BLOCK-7
UNIT - 46

"MODEL C REVERSED"
BASEMENT
FLOOR PLAN

PROJECT
SAWGRASS TOWNS
JOCKVALE RD.
OTTAWA, ON

"MODEL C REVERSED" GROUND FLOOR PLAN

"MODEL C" - GROUND FLOOR PLAN
SCALE: 1/4"=1'

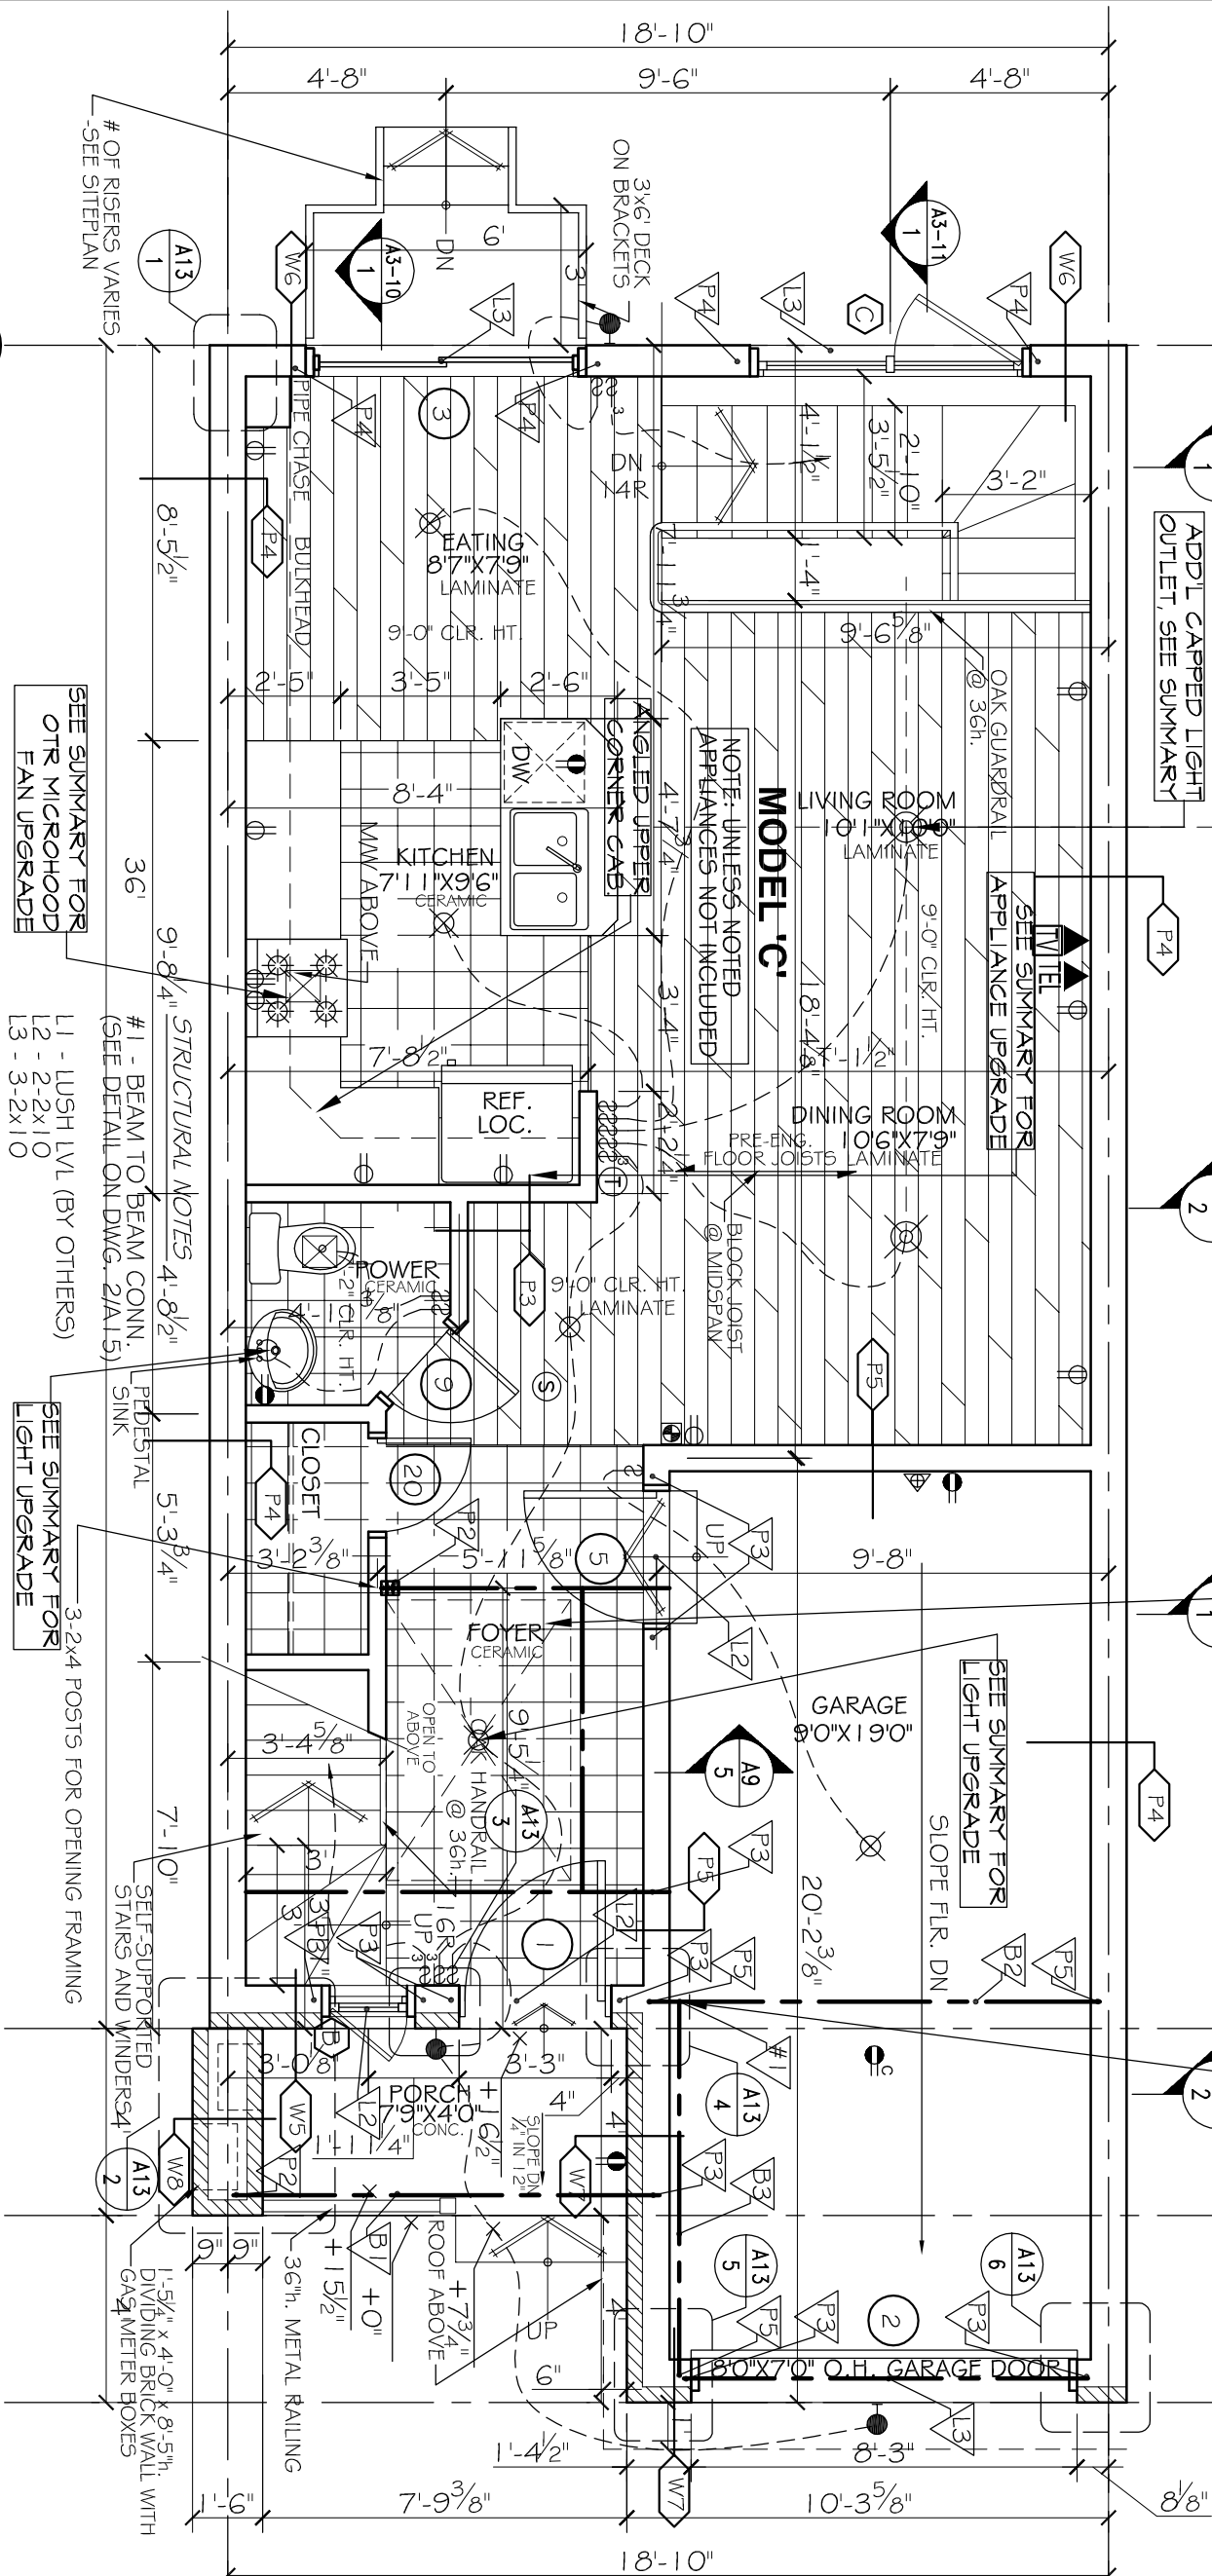
NOTE: SEE FRAMING CHANGE AROUND OPEN TO BELOW AREA AS A RESULT OF ENGINEER'S SITE VISIT ON JULY 4, 2014

NOTE: SEE ENG'S FRAMING CHANGE AS PER SITE CONDITION

ADD'L CAPPED LIGHT OUTLET, SEE SUMMARY

SEE SUMMARY FOR APPLIANCE UPGRADE

SEE SUMMARY FOR LIGHT UPGRADE

SEE SUMMARY FOR OTR MICROHOOD FAN UPGRADE

SEE SUMMARY FOR LIGHT UPGRADE
